CITY OF TAYLOR, TEXAS

PLANNING AND ZONING COMMISSION MEETING

May 10, 2022, 6:00 P.M.

Staff has completed its review of plat for the RCR-Taylor Logistics Park Phases 1, 2 & 3 Preliminary Plat that is to be located at 201 FM 3349, Taylor, TX 76574. There are some corrections that need to be made prior to approval of the preliminary plat. Your plat application will be placed on the May 10, 2022, agenda for the Planning and Zoning Commission meeting. Comments from this review follow.

RCR-TAYLOR LOGISTICS PARK
PHASE 1 AMENDING PLAT 2

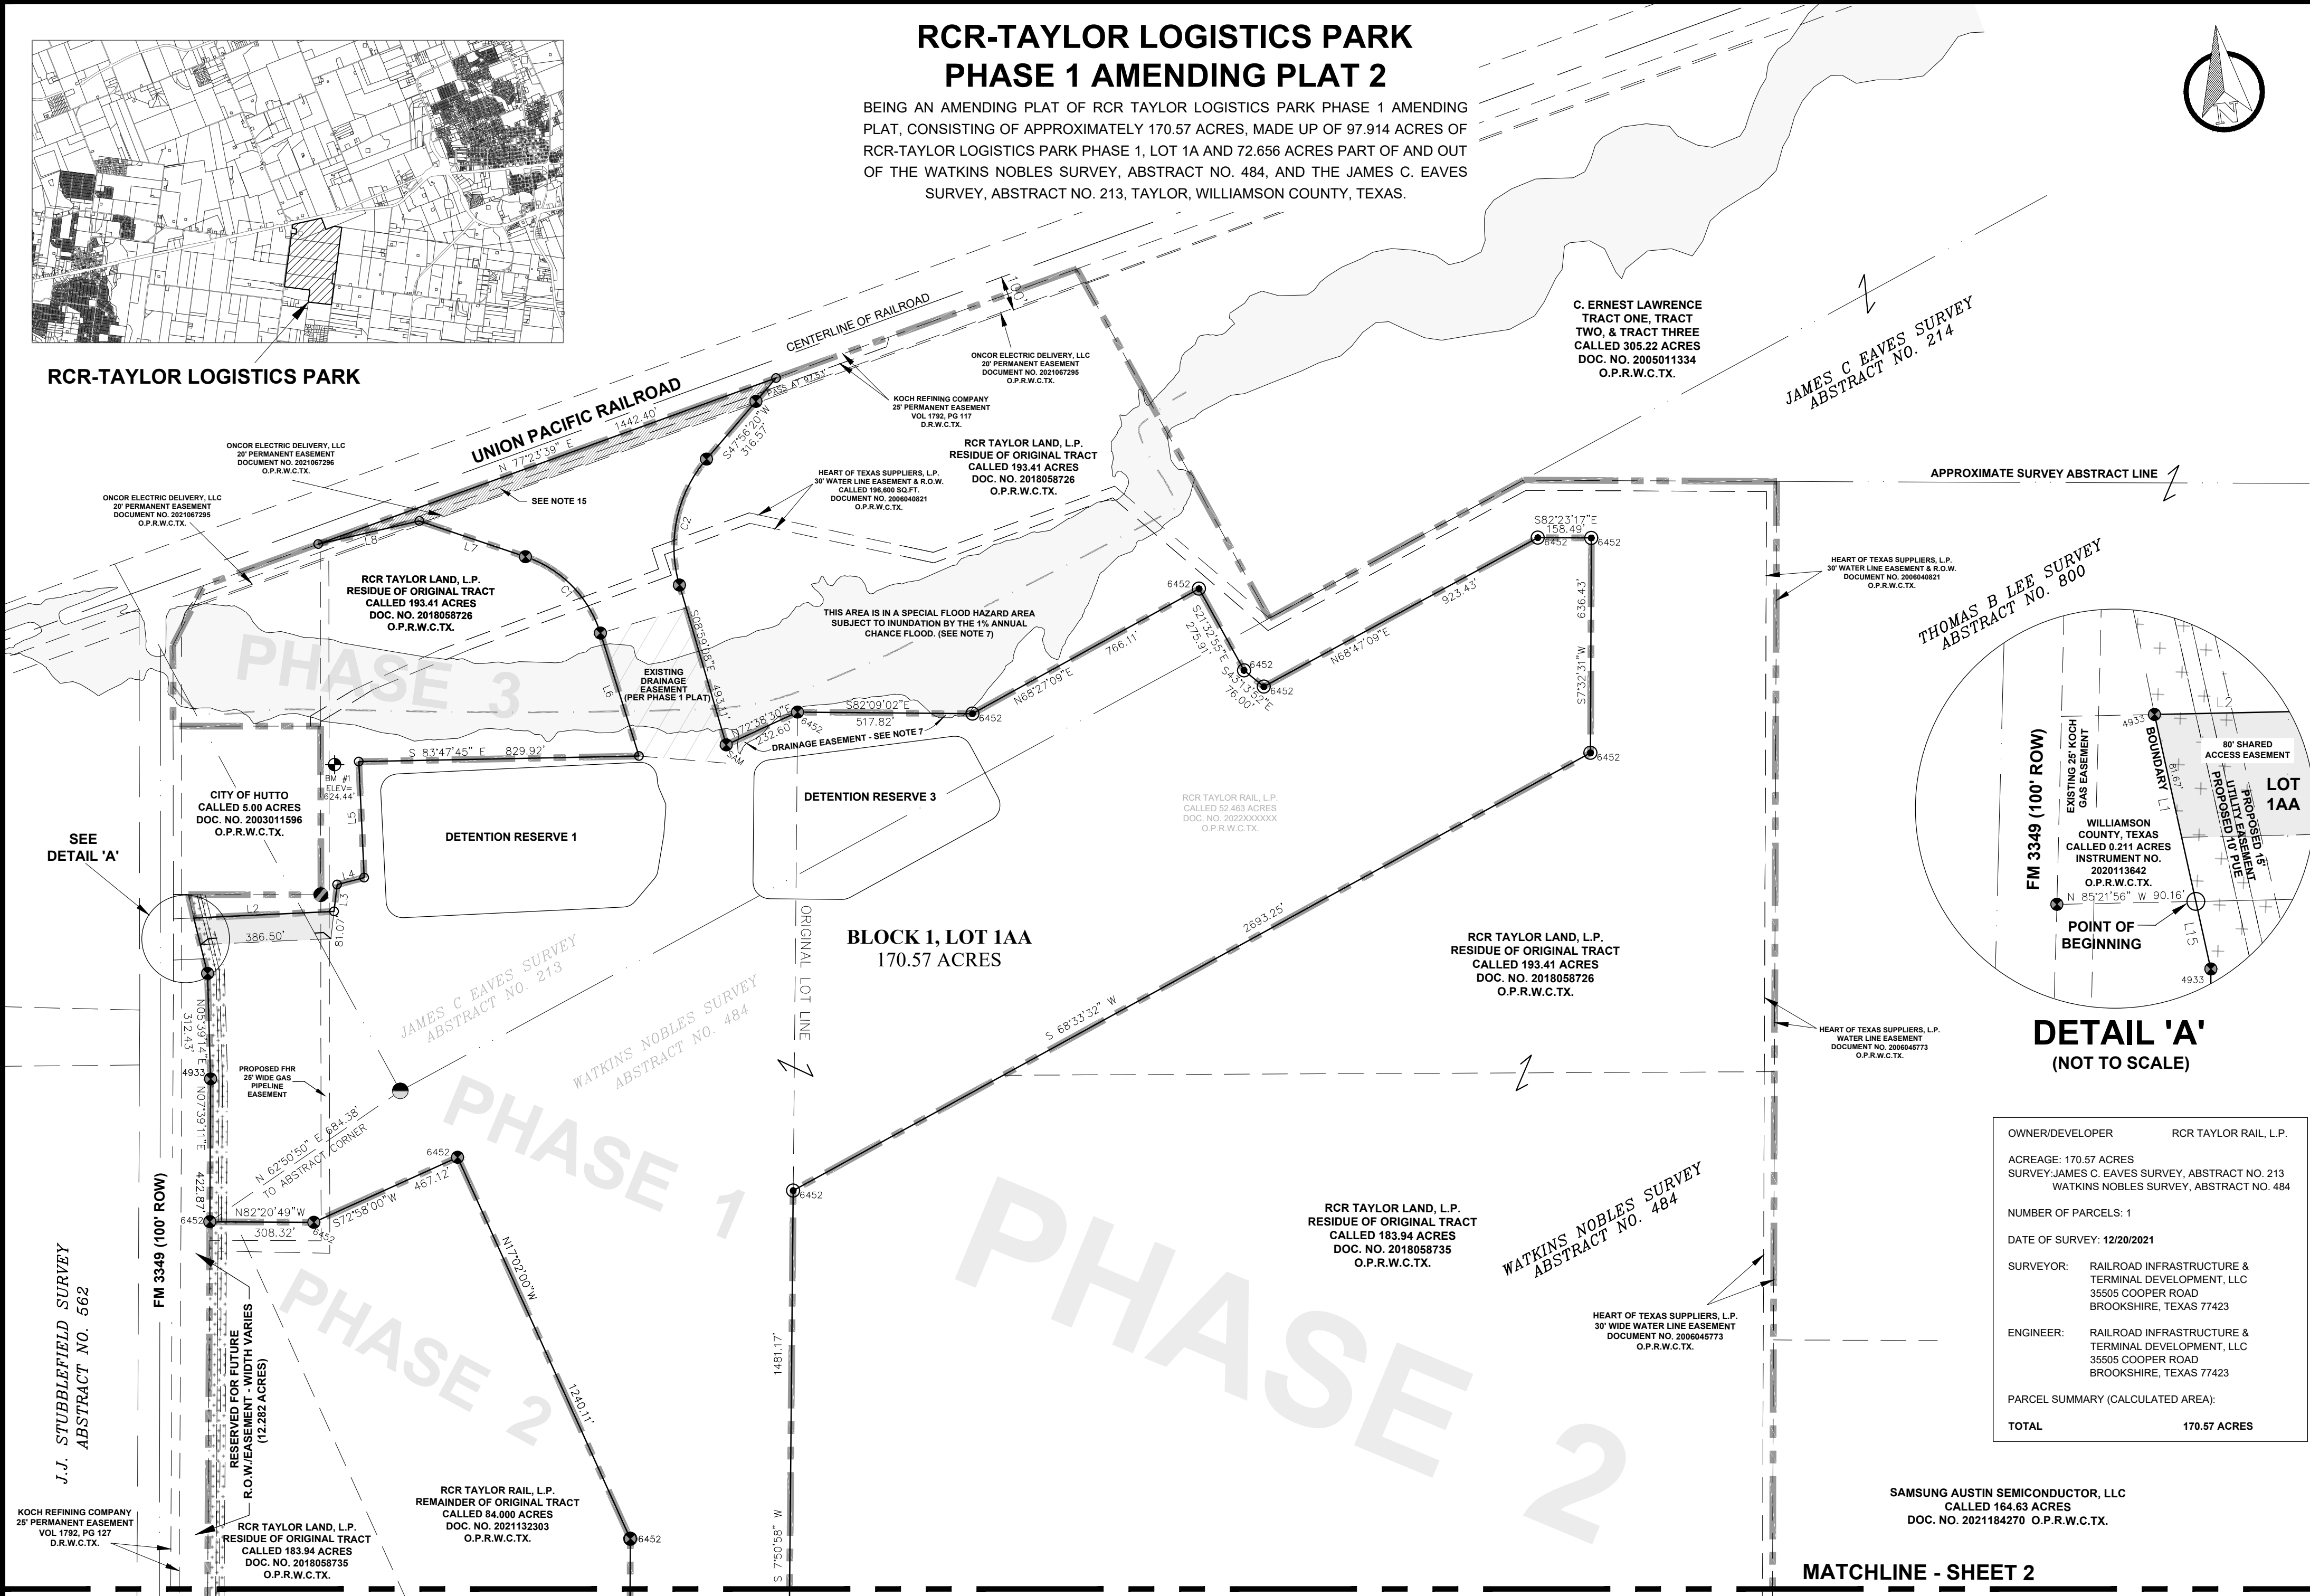
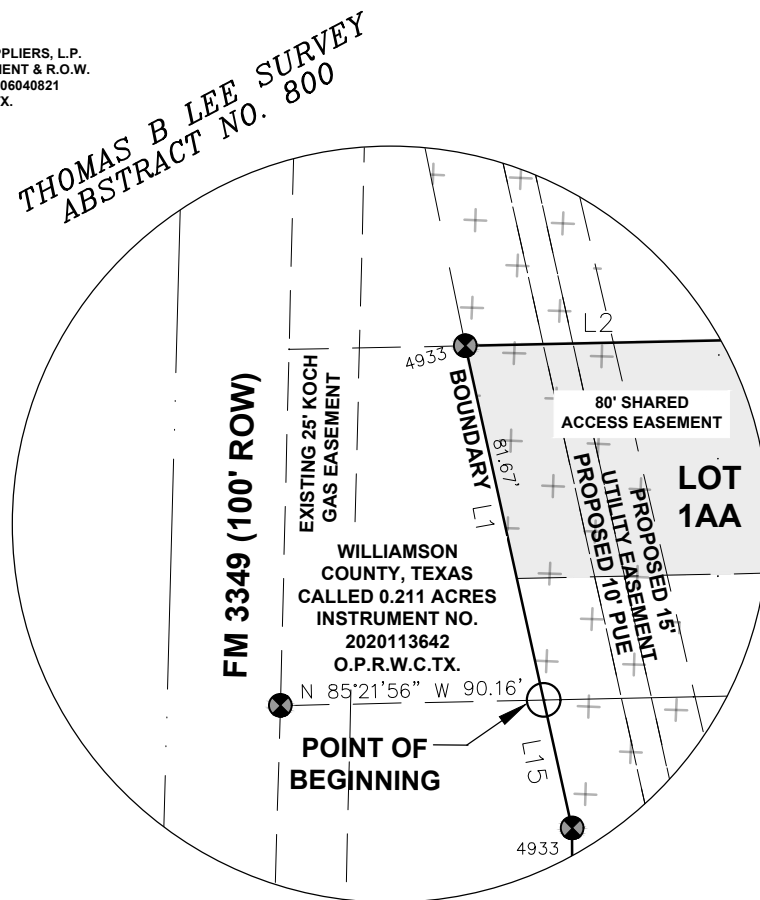
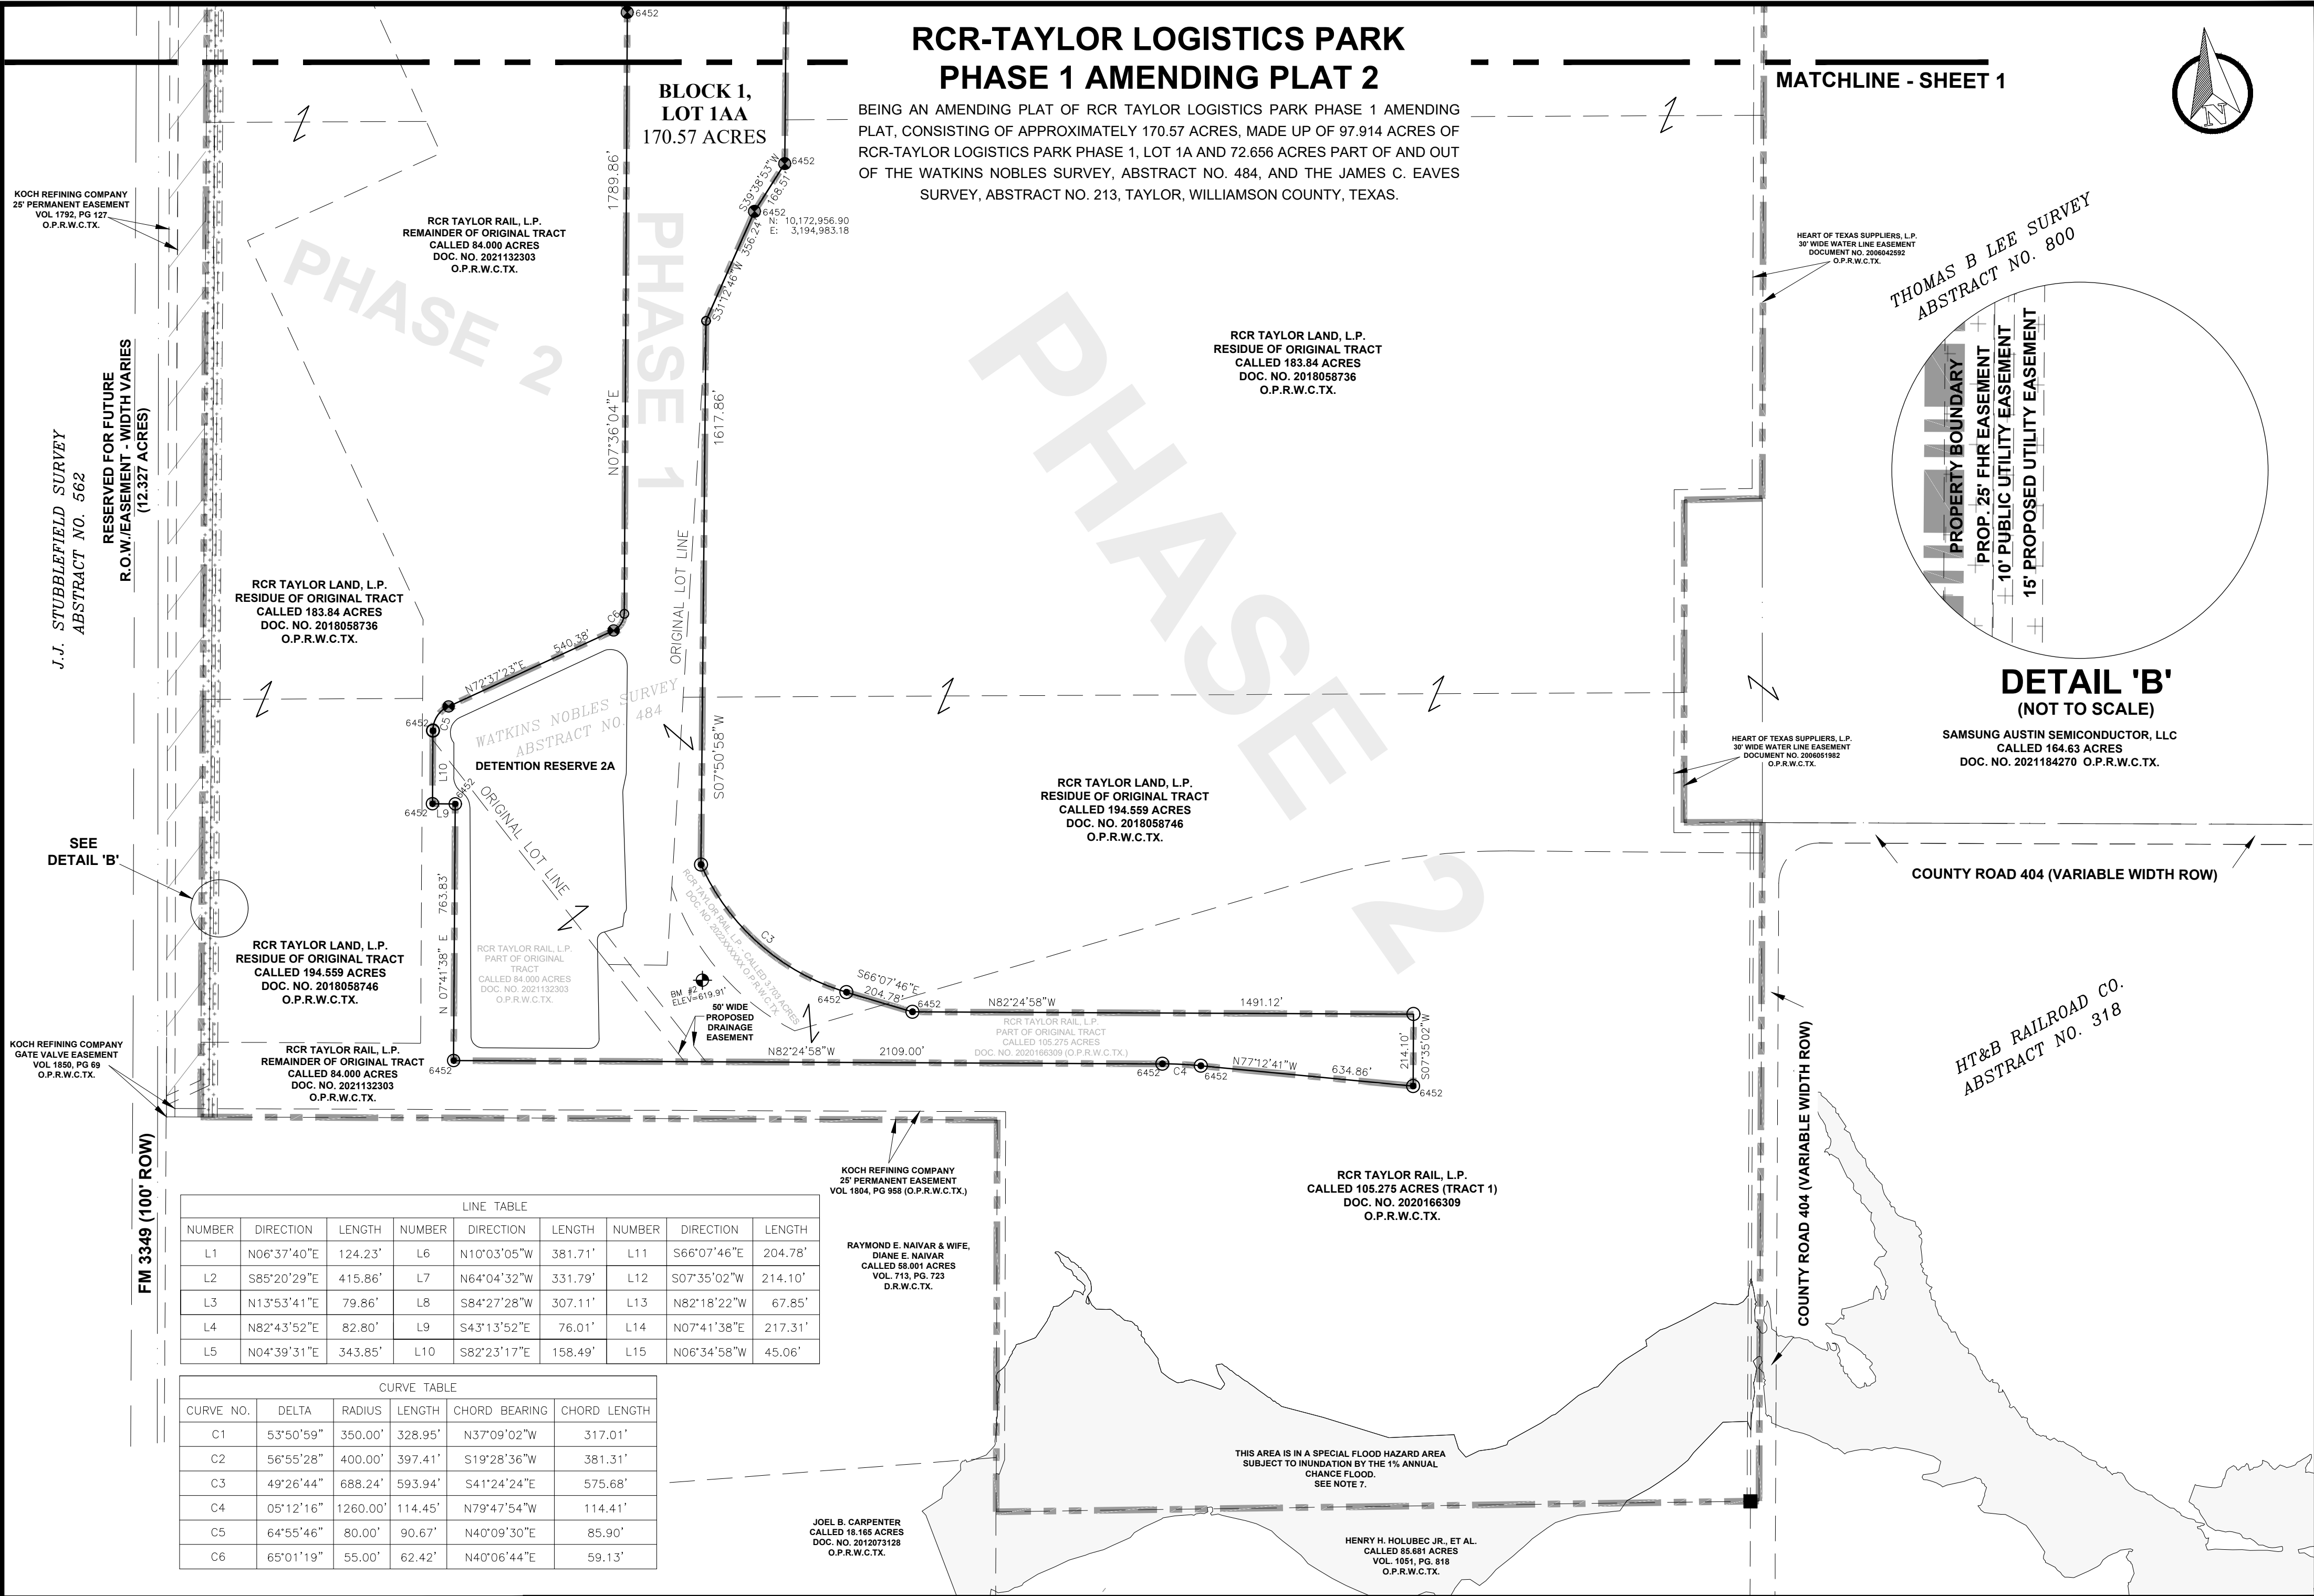
1. You didn't make correction from previous comment ..."Amending Plat 2". Comment is still current. Correct the Title of the plat everywhere. The bottom of the sheets have the wrong Title.

2. The amending plat can be approved the planned development needs to be updated so the layouts and zones are consistent.
3. Include lot boundary and adjacent property lines in the Legend. Change the color of the phase boundary line in the Legend: it's gray on the plat not black.

4. The Phase labels are too light and the deed information for the surrounding tracts is too dark. All the labels that are too light won't show up on the recorded plat. The labels that are too dark especially on the surrounding tracts add confusion to the platting process.

5. Detail 'A' must be consistent in both drawings.
6. Fill out the Revision Table.
7. Move the Match Line down so that the plat is legible. The Title and description are in the way.

8. FM 404 that goes east/west is no longer. It was abandoned.
9. Label Phases in the Details.
10. Double check the Owner's Certificate. Make sure all the numbers are correct and the plat is the correct name. Also, add Owner to the Signatory description of the Signatory.

11. Engineer's Certificate is incorrect as the Floodplain is encroaching into Phase 1 unless you change the boundary.
12. Move Note 13 so it is with all Floodplain notes.

13. Add the amending plat info to Note 4.
14. Change Note 17 so it matches the proposed update that will be approved before this is recorded.
15. Review all the mark ups that were uploaded in the review files for you.
